ADDENDUM NO. 3

Date: August 26, 2014
Project: City of Tuscaloosa
City Walk at University Place and Forest Lake
Project No. A12-1413/A12-0993
Bid Date: **Thursday, August 28, 2014**
9:00 a.m. local time
Narashino Conference Room in City Hall

CITY OF TUSCALOOSA
CITY WALK AT UNIVERSITY PLACE & FOREST LAKE
CITY OF TUSCALOOSA PROJECT NO. A12-1413/A12-0993
WHITFIELD CREEK CROSSING

Section 03
Scale: 3/4" = 1'-0"

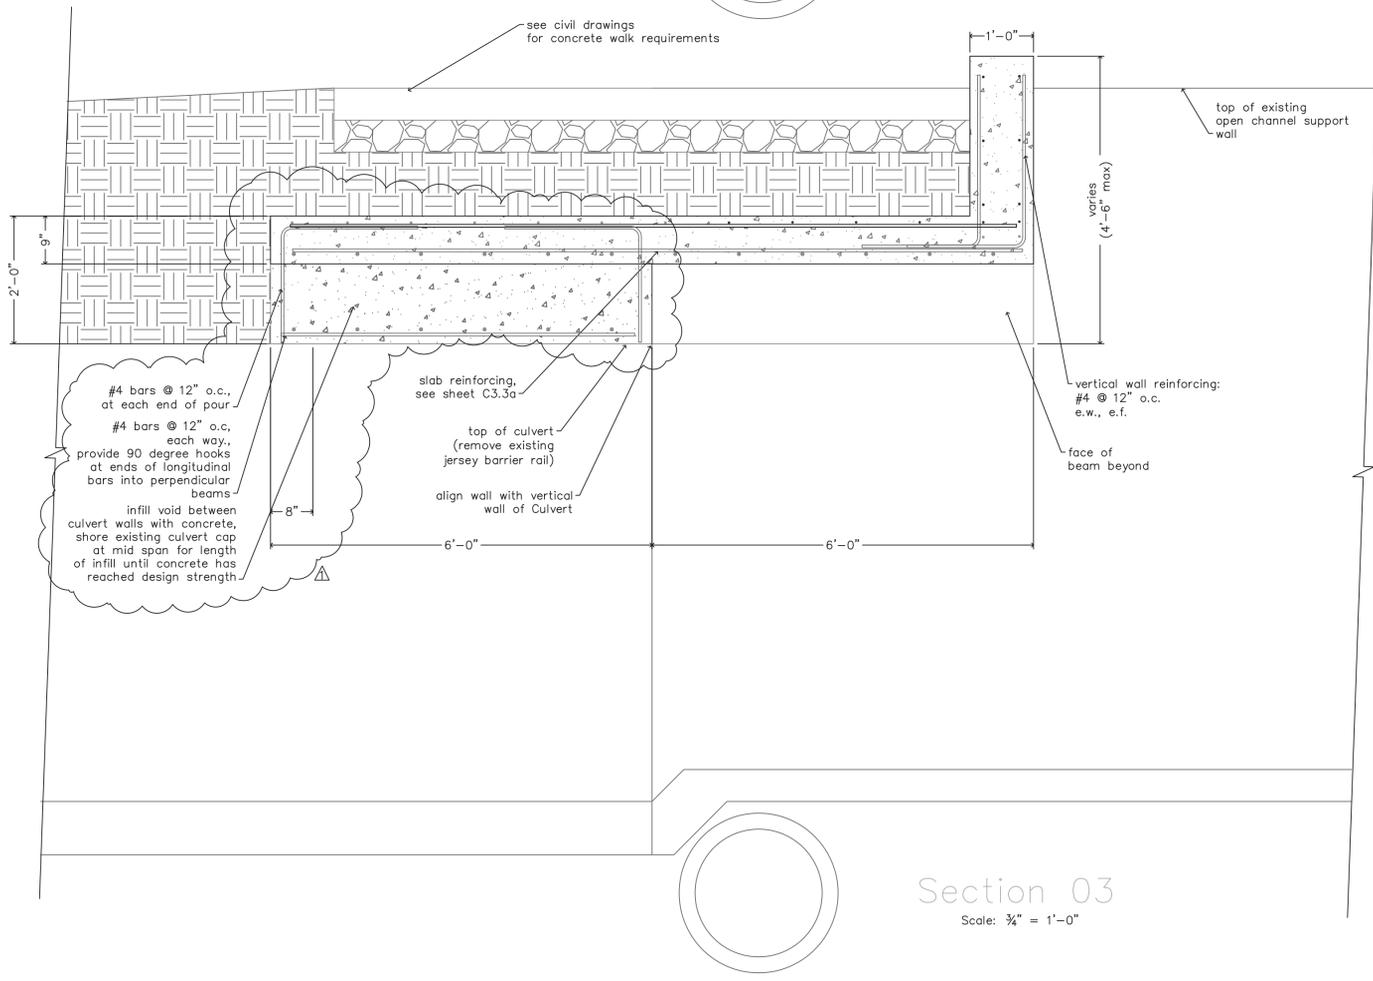
1. Construction Plans:
 - a) Sheet C3.3b.0 – modification to Section 03
